Maule Aircraft Corporation

SERVICE LETTER #49

SUBJECT: New Flap Ratchet.

AIRCRAFT AFFECTED: MAULE Model M-5-180C, Ser. No. 8001C thru 8022C.

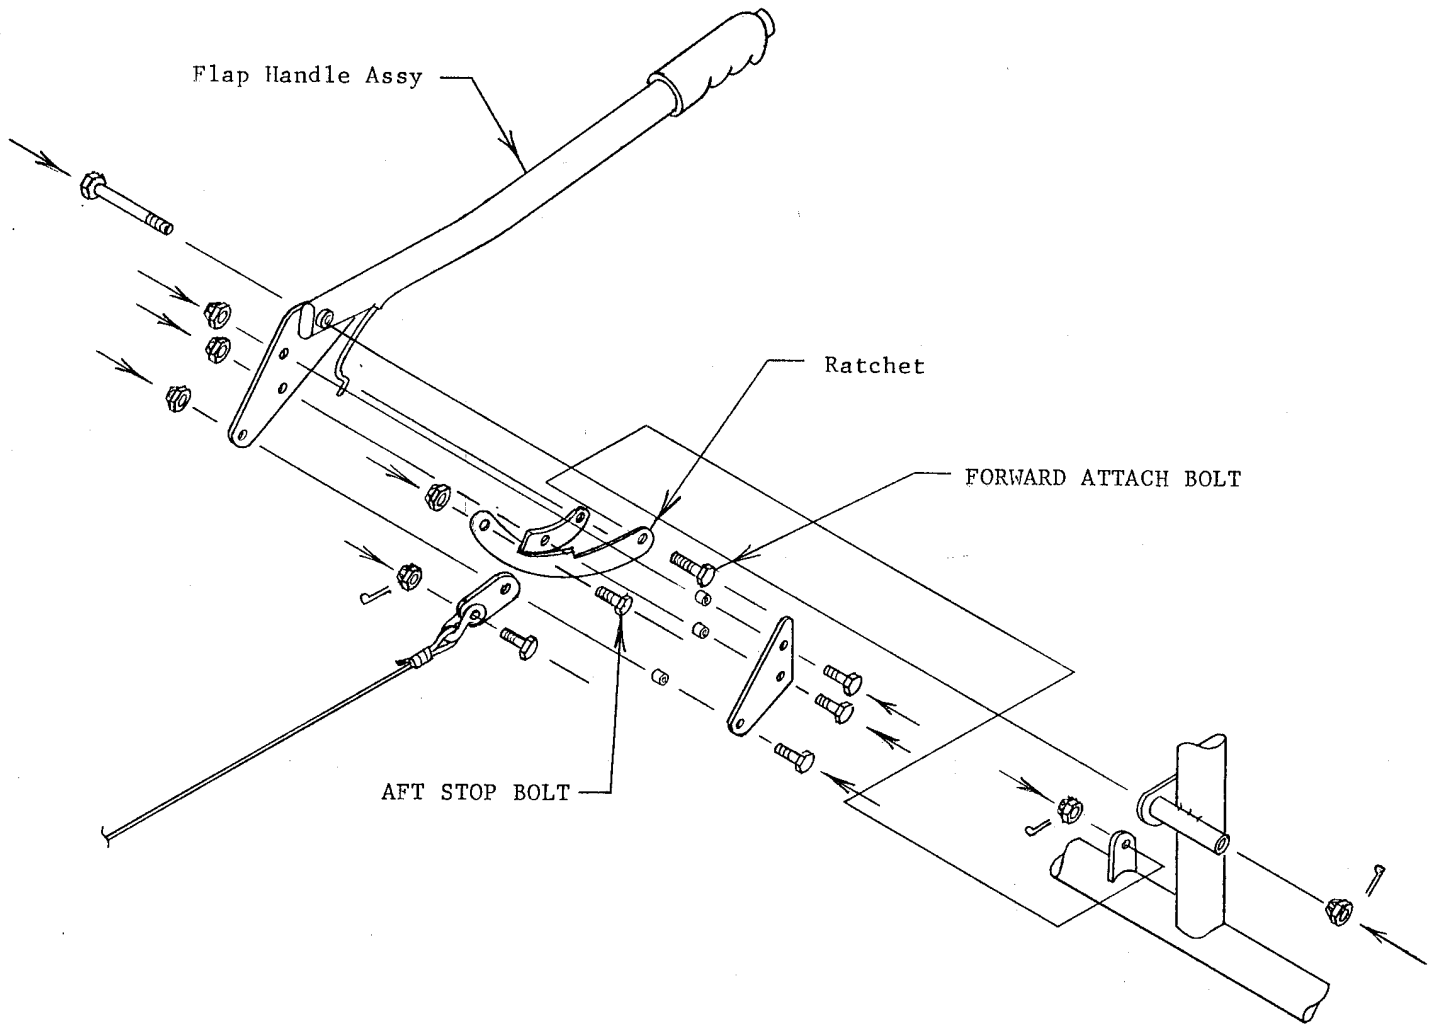
BACKGROUND: Many MAULE owners have requested increased flap travel for their airplanes. The new flap ratchet allows 5° - 8° more travel at each setting. There is also available an alternate lever which is bent upward. This allows more clearance under the lever for easier grasping. Either unit can be used separately.

1. Remove left front seat.
2. Remove control cover (ref. Item 6, Group C-4 of Parts Catalog)
3. Remove old ratchet: (See Sketch on page 2)
 - (a) Remove forward ratchet attach bolt and nut.

- (b) Remove aft stop bolt and nut.
 - (c) Slide ratchet forward thru plates of flap handle assembly.
4. Install new ratchet:
 - (a) Slide ratchet aft thru plates of flap handle assembly.

- (b) Install forward attach bolt and nut and secure with cotter pin.
 - (c) Install aft stop bolt and nut removed from old ratchet.
NOTE: 20°-40° ratchet has forward stop bolt and nut deleted.
